service bulletin

Actuator Seal Failures - Quicksilver Power Steering

P/N 17443A2, A3, A7, A8, A10, A11

Figure 1. Fluid Level.

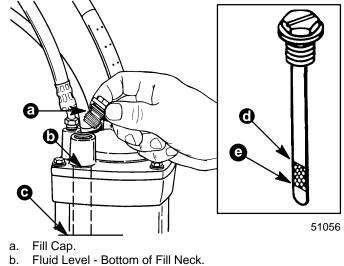
<u>Overfilling the Reservoir</u>. A caution decal has been developed to provide convenient instructions on how to check and maintain the oil level in the reservoir. Order caution decal p/n 37-826190 and install next to the oil fill hole on all in-stock and customer owned power steering units that do not have the decal. Also, explain the proper fluid checking/filling procedure to the customer.

- 1. Turn key off.
- 2. Release fluid pressure by steering thru the full steering range (stop to stop) three (3) times, then extend the steering ram full out.
- 3. Remove fill cap. NON-DIPSTICK MODELS: fill with fluid to bottom of fill neck (b). Actual fluid level in reservoir will be at the bottom of the fill tube (c). DIPSTICK MODELS: fill with fluid to the dipstick full mark (d). DO NOT OVERFILL.
- 4. Thread fill cap in two full turns. DO NOT TIGHTEN.
- 5. Turn key "ON". Activate the system by steering thru the full steering range (stop to stop) three (3) times, then extend the steering ram full out. DO NOT REFILL OIL RESERVOIR.
- 6. Tighten fill cap with steering ram extended full out.

Figure 5. Improved Actuator Yoke.

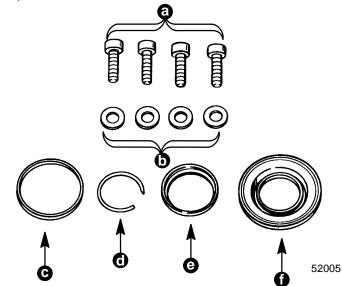
This is the same actuator yoke assembly that is installed in p/n 17443A11 power steering units and is identified by the square yoke end. The previous actuator yoke has a round end.

<u>Aggressive Steering Maneuvers.</u> An actuator yoke assembly kit p/n 826641A1 has been developed to avoid actuator yoke seal failures due to aggressive steering maneuvers on 17443A2, A3, A7, A8 and A10 power steering. The actuator yoke assembly has an improved actuator yoke and bushing. It comes fully assembled with four (4) new attaching screws and installation instructions.
